Product Change Notification

TRIMPOT® TRIMMING POTENTIOMETERS

REVISED MAY 30, 2014

New Housing Design for Model 3386 T Version Trimpot® Trimming Potentiometer, All Pin Styles

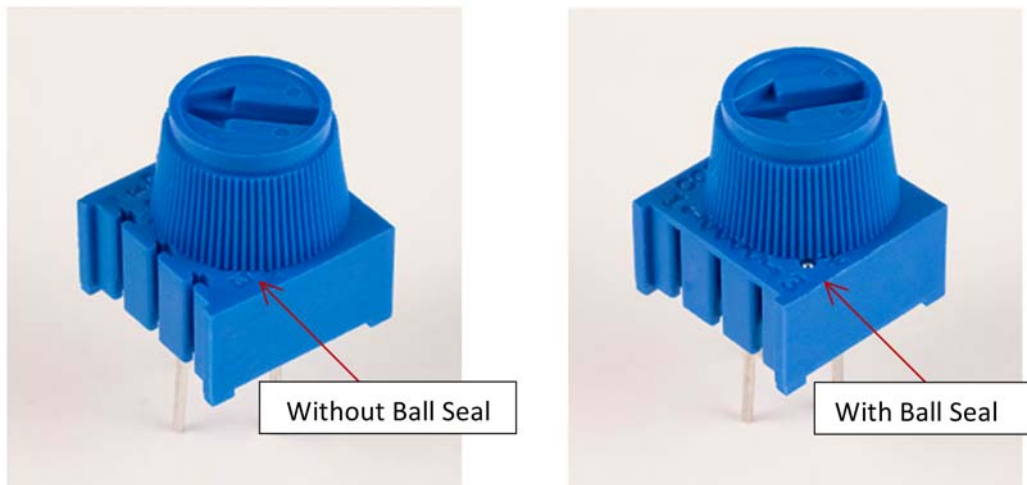
Bourns Trimpot Product Line announces a new housing design for the Bourns® Trimpot® Trimming Potentiometer [Model 3386 T Version](#), all pin styles. This change applies to the model with the knob feature and/or extended rotor.

There is no change to fit or function. However, the new design requires a ball seal on the housing, which changes the form. There are no changes to any of the electrical specifications or to the performance of the product. The first date code to identify the changed products will be 427C.
